To: Steve Teel, LHG (Ecology)
From: Hannah Morse, E.I.T. and Chris Waldron, P.E.
Cc: Jake Lund, P.E. (City of Olympia), Nicholas Acklam (Ecology)
Date: November 12, 2021
Subject: Meeting Minutes from 11/02/2021 Meeting with Ecology to Discuss Groundwater Comments on the 2015 Solid Wood RI/FS Report

West Bay Park RI/FS

GROUNDWATER DISCUSSION

Response/Discussion of Ecology's Significant Comments and Path Forward for the RI/FS Report

| <p>PIONEER TECHNOLOGIES CORPORATION</p> | <p>Groundwater Sample Locations Remedial Investigation/Feasibility Study Report Solid Wood Incorporated Site Olympia, Washington</p> | <p>Figure 3-4</p> |

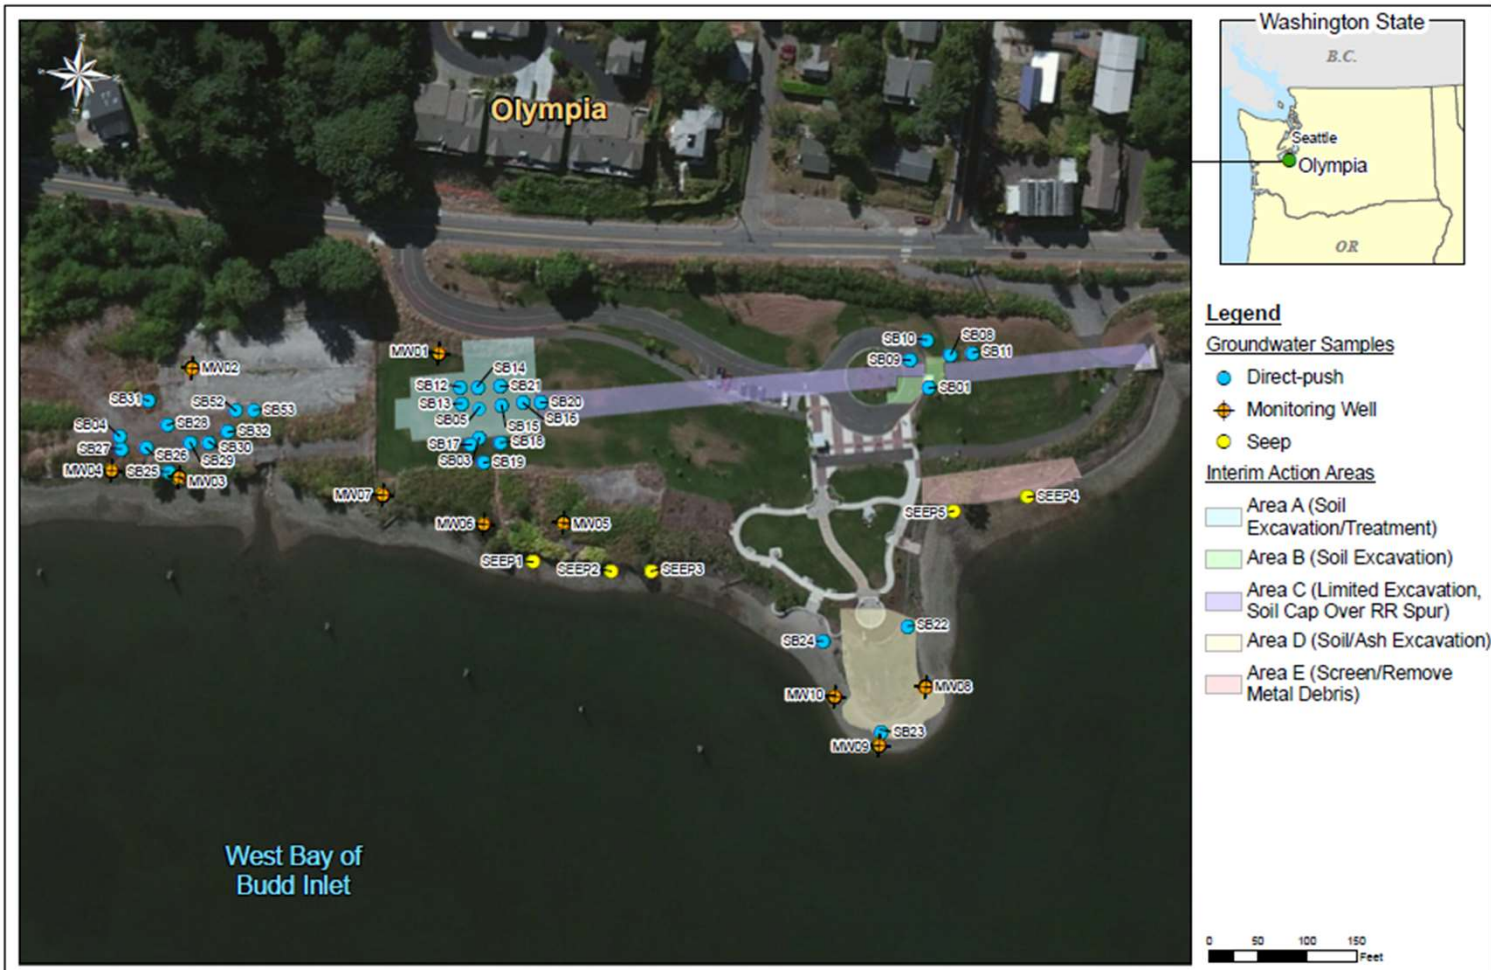
- Ecology Comment: Currently there is insufficient data for Ecology to conclude that the “Harbor Island exemption” is applicable for the Site. WAC 173-340-720(2)(d) lists specific criteria, each of which must be satisfied...

- Recap of Previous Discussion (07/13/2021):
 - Harbor Island Exemption was not based on well yield data as described in Ecology’s comment
 - Groundwater at the Site is very shallow (4 – 14 feet bgs)

- MW03, MW04, MW05, MW06, MW07, MW08, MW09, MW10 installed on the shoreline
 - MW01 and MW02 are located slightly inland (~100 to 150 feet from shoreline)

- 2014 study of GW and SEEP samples showed that Copper and Nickel concentrations in GW were similar to background concentrations in Budd Inlet. This conclusively demonstrated that the groundwater on site is hydraulically connected and is significantly impacted by surface water in Budd Inlet.

- Additionally, typical chloride concentrations in groundwater are approximately 100 mg/L, but chloride concentrations in groundwater have ranged from 1,100 mg/L to 13,000 mg/L. This is further evidence that groundwater is hydraulically connected to surface water.

- The City does not agree that groundwater at the Site should be classified as potable but is moving forward, per Ecology’s comments, with a potable water evaluation in the RI/FS Report.

Preliminary Groundwater COC Evaluation

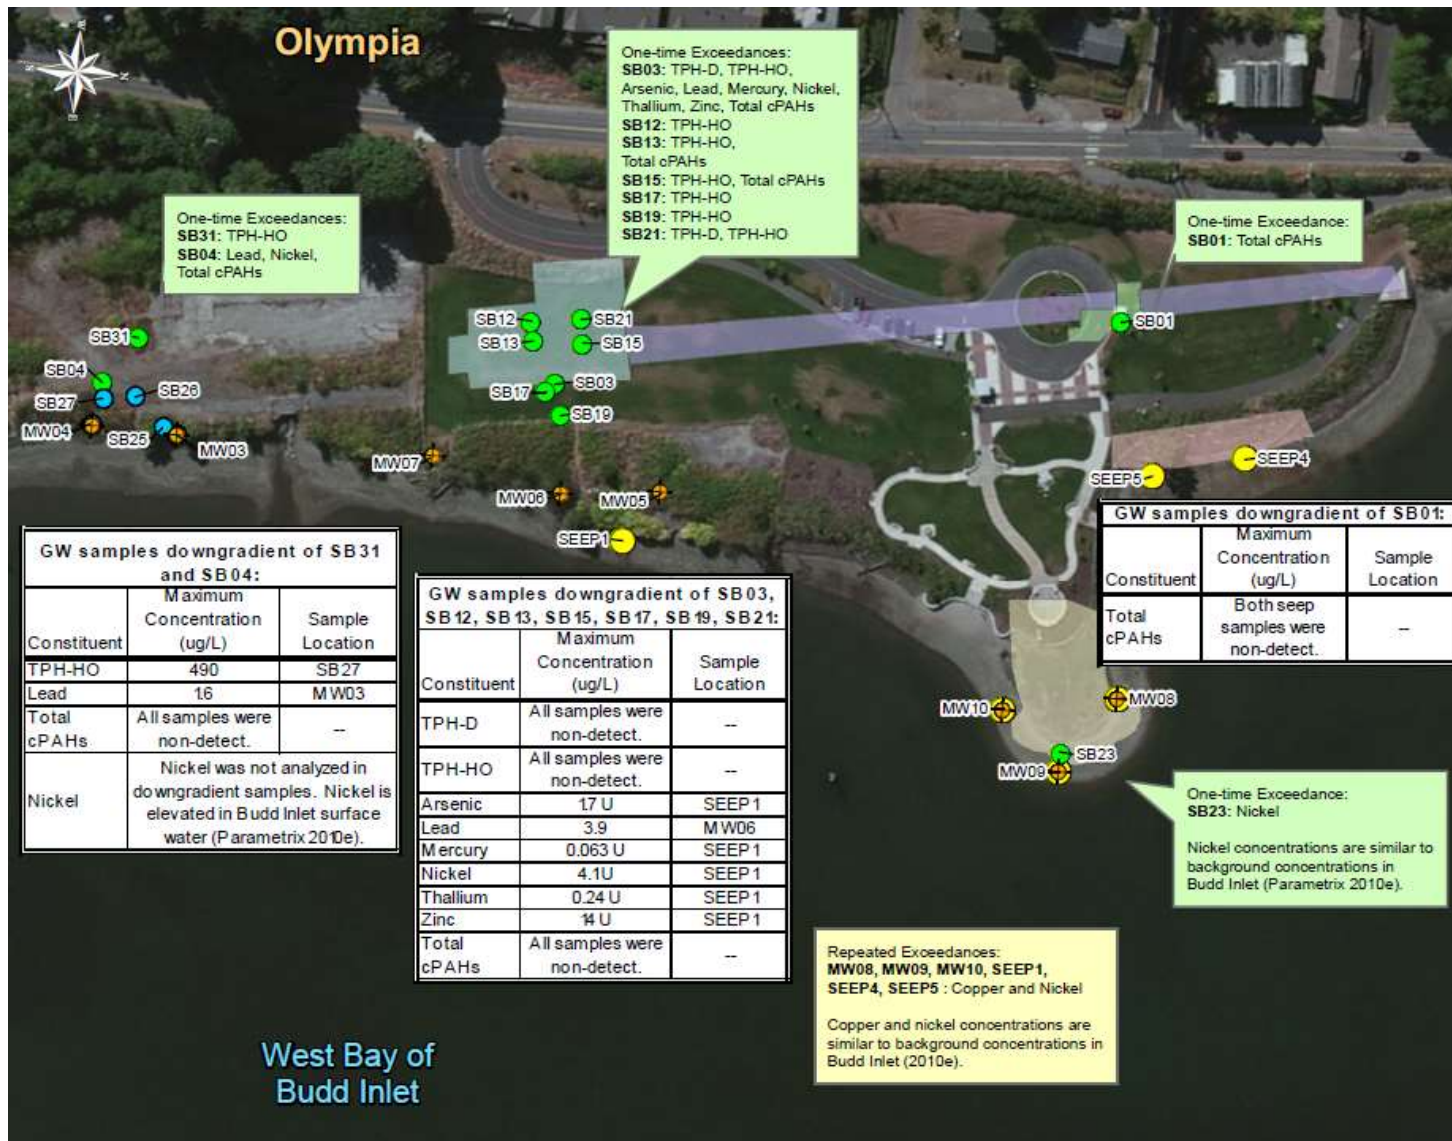
Values were updated based on Ecology Comment #25a. Values are the most stringent of all applicable or relevant and appropriate requirements (ARAR) values referenced in WAC 173-340-730(3)(b)(i) (i.e., Chapter 173-201A WAC, Section 304 of the Clean Water Act, and 40 CFR 131) for marine waters. Obtained from CLARC (October 2021).

- All Exceedances are in Direct Push Borings.
- Most were removed during IAs.
- No Exceedances in Monitoring Wells.

Groundwater COC Evaluation (Continued)

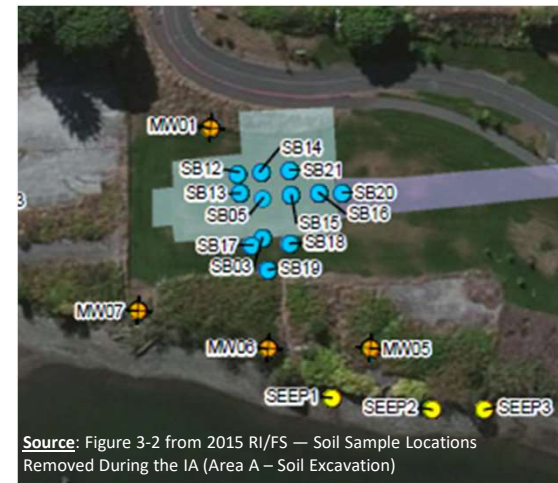
- TPHs
 - TPH-D exceedance in SB03, SB21
 - TPH-HO exceedance in SB03, SB12, SB13, SB15, SB17, SB19, SB21, SB31
 - No exceedance in four quarters of groundwater monitoring at MWs downgradient from exceedance locations (WAC 173-340-720[9][a]) or in a downgradient sample collected.

- Indication contamination has not migrated
 - GW monitoring results (no exceedances) are representative of current conditions since source contamination (soil) was removed as IA in Area A

- Arsenic
 - Only exceedance in SB03 (soil removed as part of IA in Area A)
 - Downgradient concentrations were non-detect, indication contamination is not migrating

- Cadmium
 - Only exceedance in SB03 (soil removed as part of IA in Area A)
 - Maximum detected concentration was 5.1 ug/L, only slightly exceeds GW CUL (MCL = 5.0 ug/L)

- Downgradient concentrations were non-exceedance and/or non-detect
- Lead
 - Exceedances in SB03 (removed during IA Area A) and SB04.
 - No exceedance in four quarters of groundwater monitoring at MWs downgradient from exceedance locations (WAC 173-340-720[9][a]) or in a downgradient sample collected.

Preliminary Soil-to-GW/SW COC Evaluation

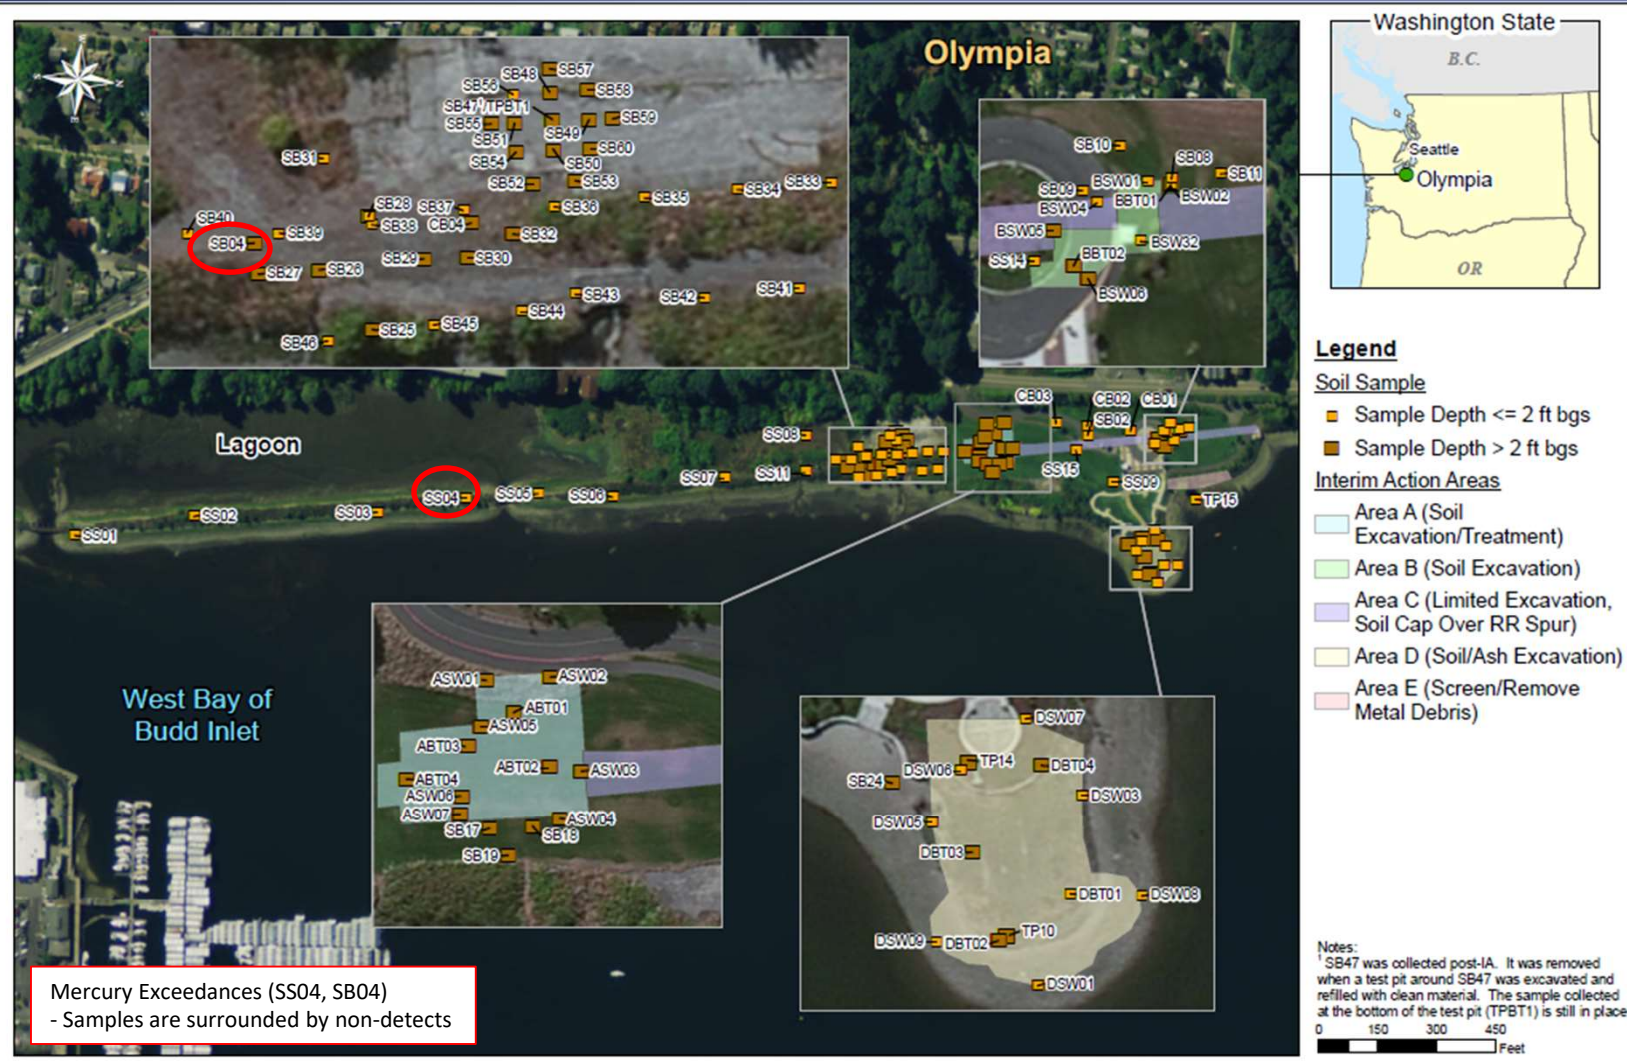
- Ecology Comment: Based on the data collected to date, as indicated in the responses above, Ecology does not agree that the Cap/Cover Alternative adequately protects groundwater.

- Recap of Previous Discussion (07/13/2021):
 - Soil-to-GW/SW Pathway is Incomplete:
 - Empirical Demonstration – 4 Quarters of groundwater data collected from MWs showed no exceedances of MTCA CULs

- All groundwater exceedances were “one-time” exceedances in direct push borings and most were removed during the interim actions (IAs)
 - Modeling-Evaluation

- MTCA 3-Phase Model was performed in the RI (Section 3.3.4.1)
 - Calculated per WAC 173-340-747(3)(a)
 - Only copper and nickel were detected at concentrations exceeding soil-to-gw/sw screening levels

- Copper and nickel exceedances were attributed to background concentrations in surface water due to the proximity of Site groundwater to Budd Inlet surface water (Parametrix 2014).
